WRONG SCREW IN OPTIONAL PACK

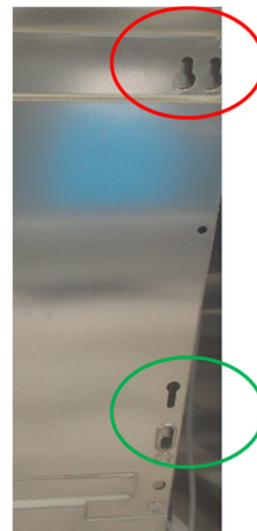
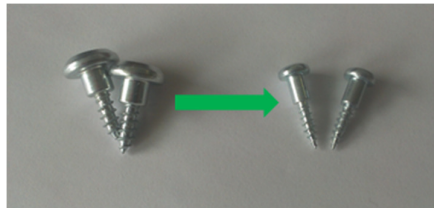
We would like to inform that from week **11/2015** factory has modified outer doors. Two holes for fixing screws have been removed. Due to this only lower holes should be used to position the wooden panel.

From week **11/2015** to week **24/2015** factory produced dishwashers with wrong optional pack (wrong screw - **4,5x18** instead of **3,5x19**) and drilling template (holes for screw in incorrect positions).

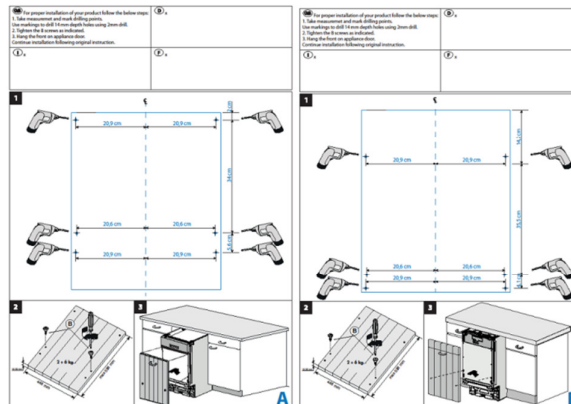
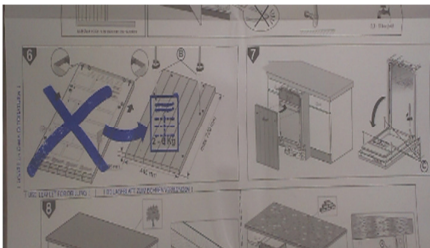
Temporarily from week **25/2015** there is used leaflet attached to drilling template showing proper position of screws.

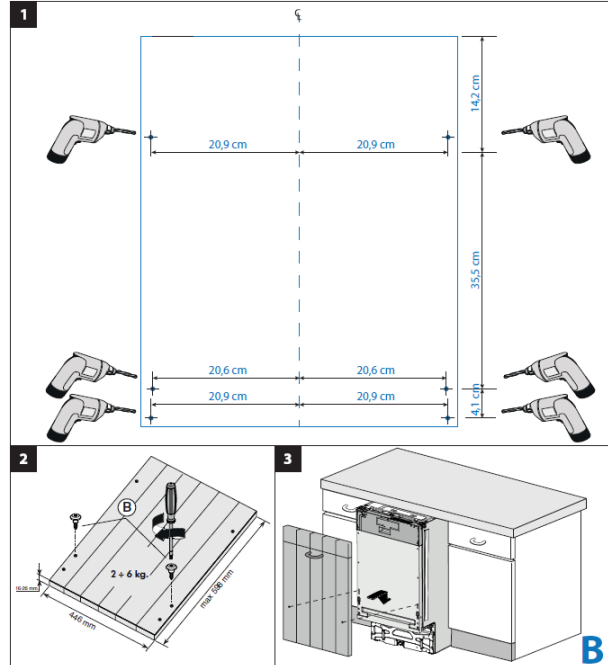
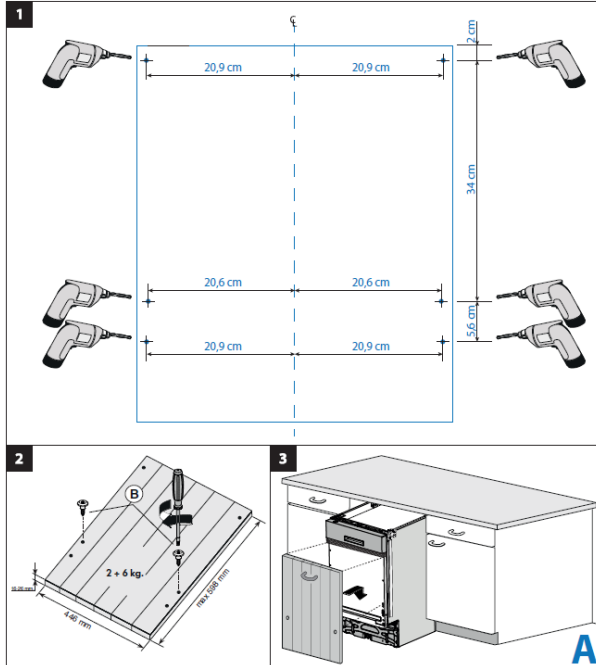
To fix issue in the field, both following actions have to be done:

1. Order 2 screws **14000590017**
2. Drill the hole according to leaflet or new drilling template (BI (picture A) or FI (picture B) version of an appliance)
